Comments on the Analysis of dE/dx vs. Wire Tension in A. Lister, DUNE-doc-20861-v1

Tom Junk

DUNE APA Technical Board Meeting

November 6, 2023

Fig. 16

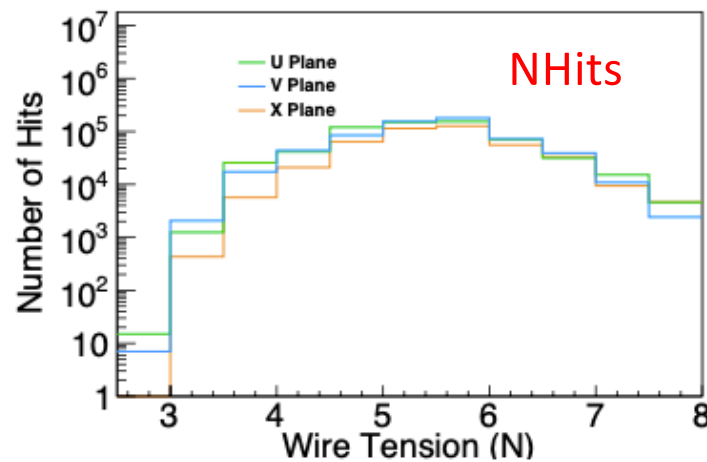
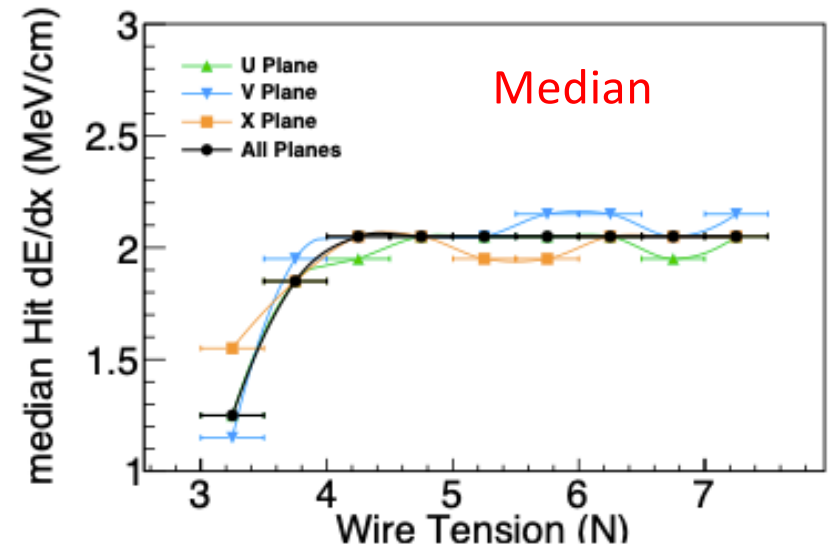
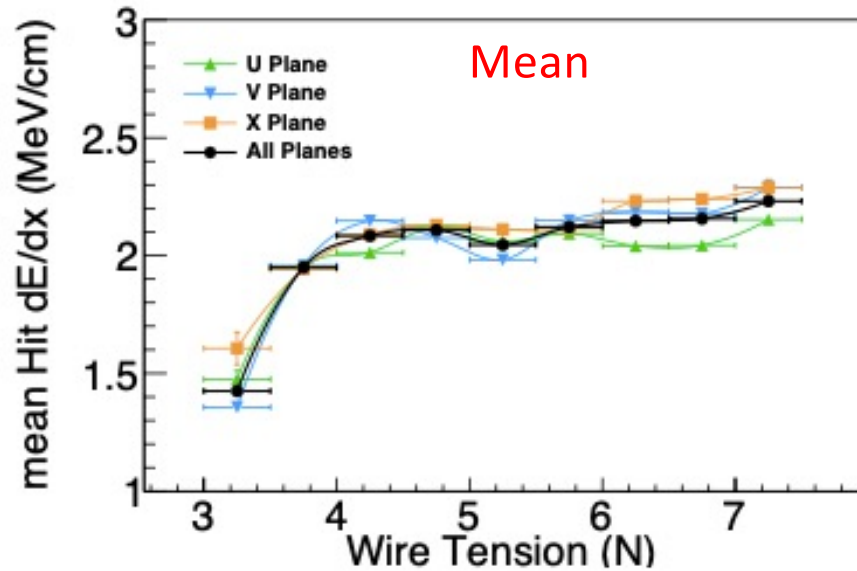
No error bars drawn on median

Figure 24: Mean (top) and median (middle) dE/dx values as a function of wire tension for APAs 3 (UK001, left) and 4 (US003, right). In addition, the number of hits used in each tension bin is shown (bottom).

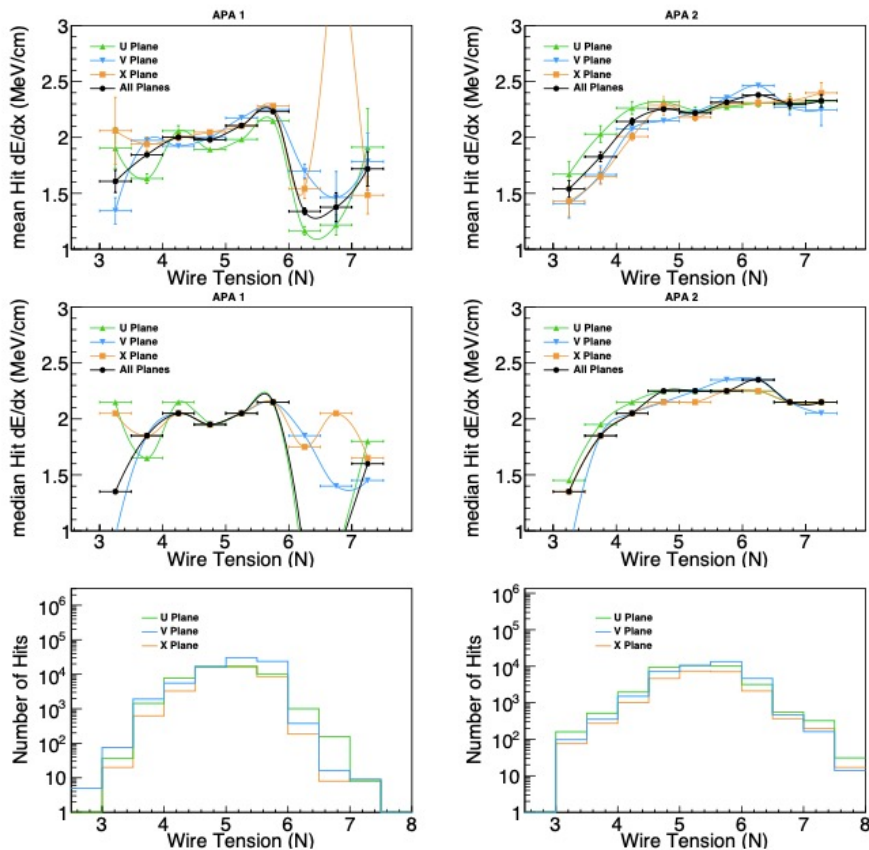
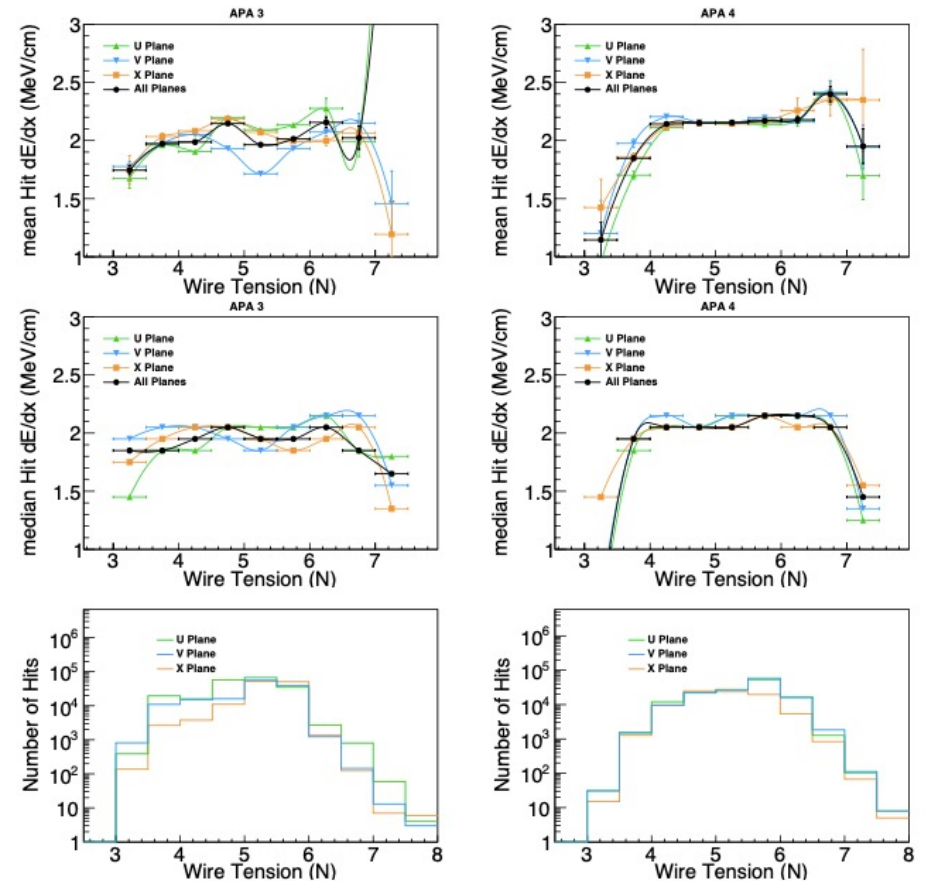
If you take the error bars seriously, there might be problems at high tensions too, on some APAs. Or even some intermediate tensions.

So What's Happening Here?

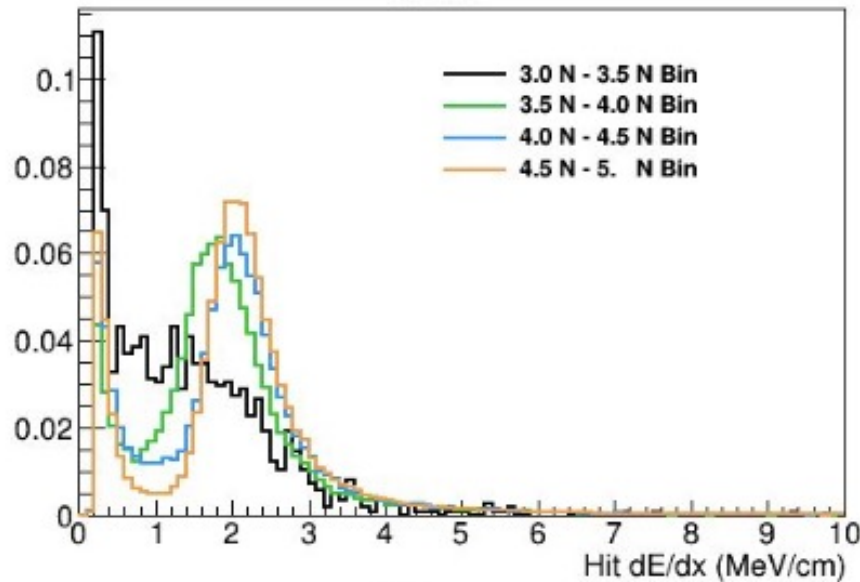
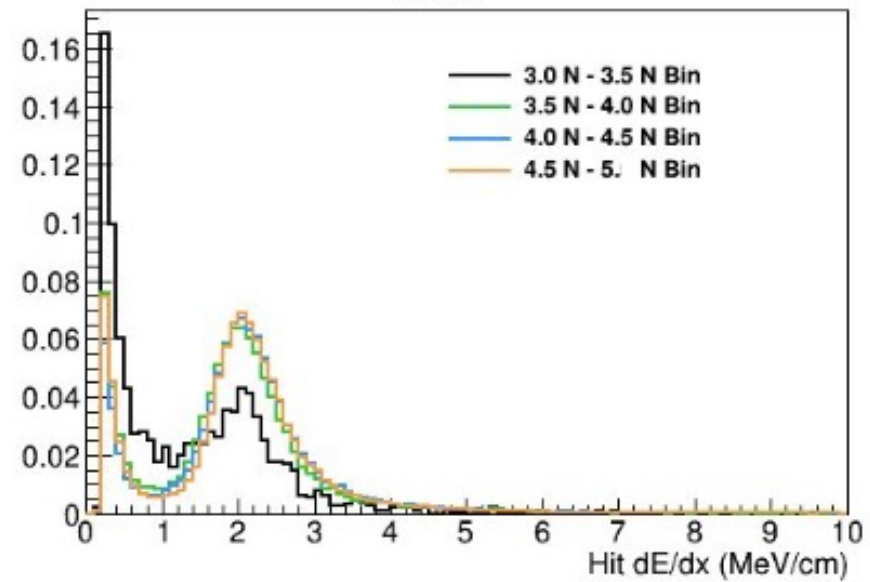
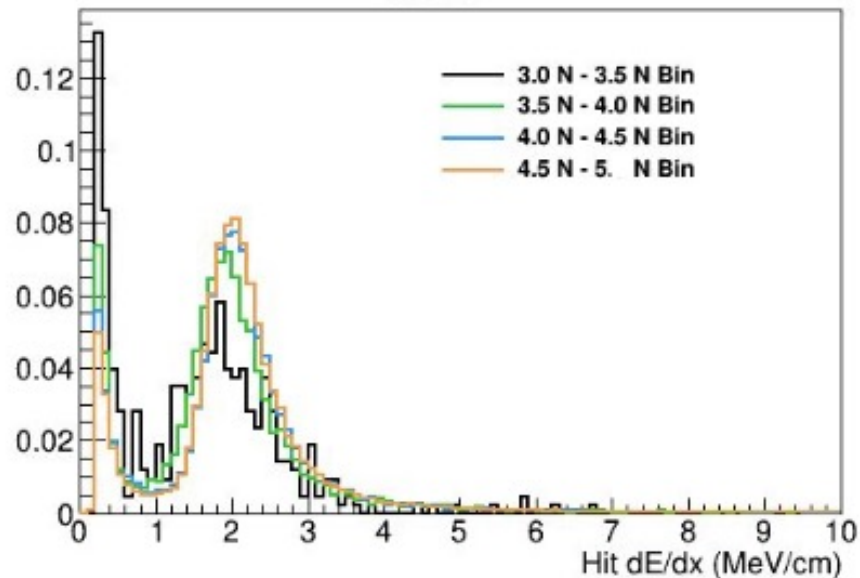
As the tension is reduced

- there are small shifts in the dE/dx peak
- there is a large increase in the number of *very low* dE/dx values, and this is likely what drives most of the effect

The first I think could be calibrated out, the second is more difficult to deal with

Figure 3–3: A surface plot of the electric potential distribution near the wire planes. The voltages on the wire planes are biased to provide complete electron transparency through the first three planes, and complete collection on the fourth plane.

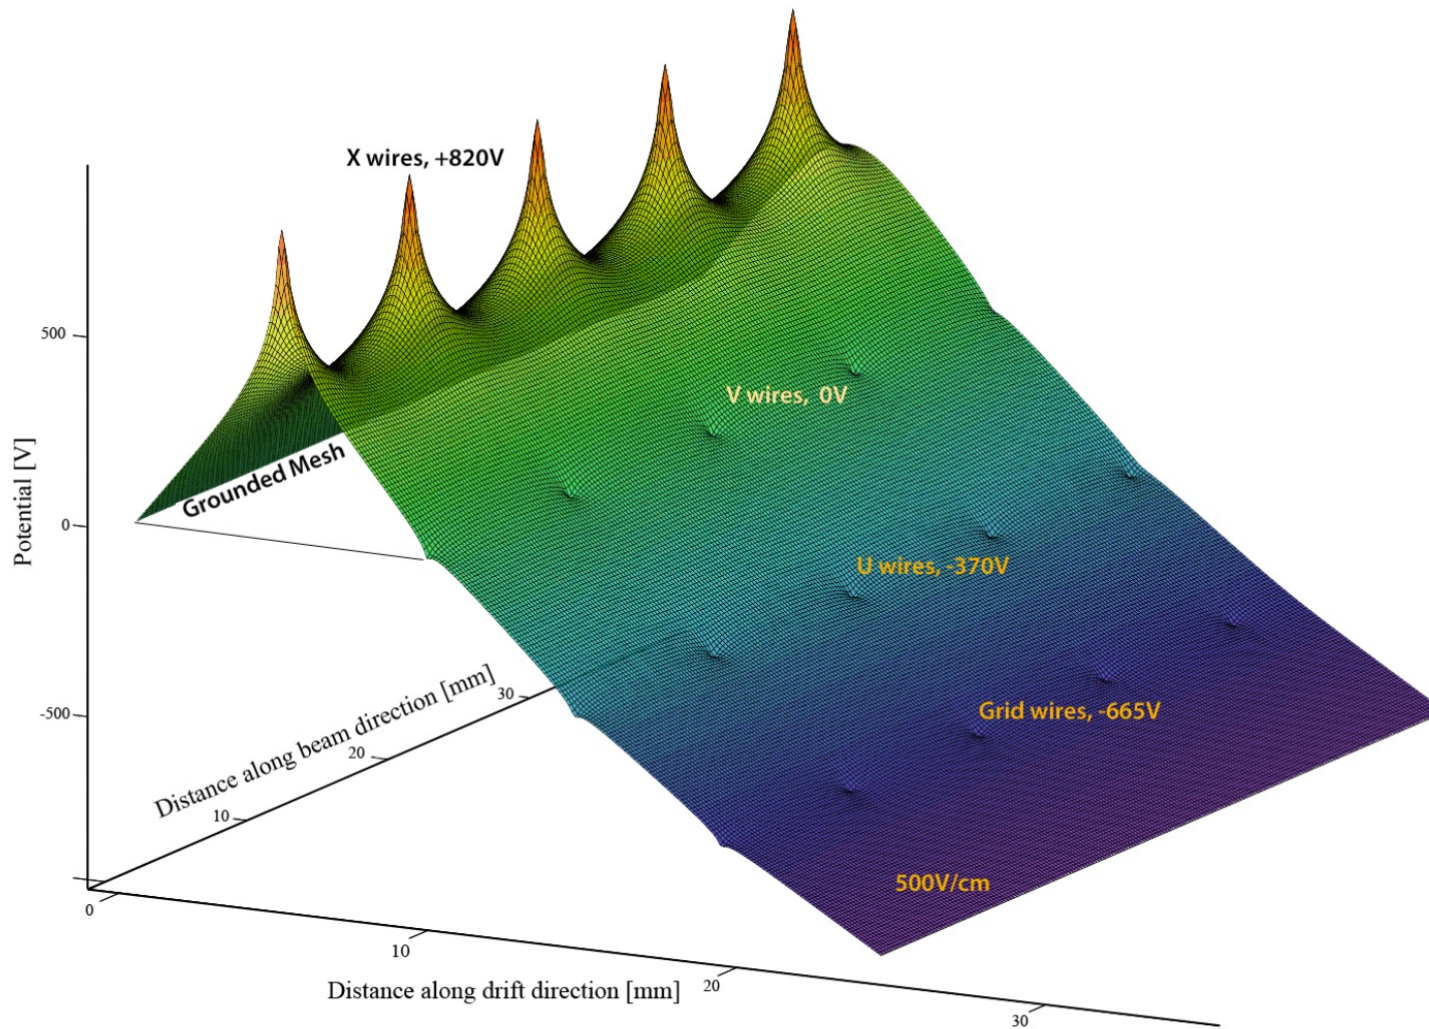
Horizontal electrostatic forces on all wire planes are very small, and get smaller if the wires sag to relieve stress.

Most of the electrostatic force on an APA is carried by the mesh.
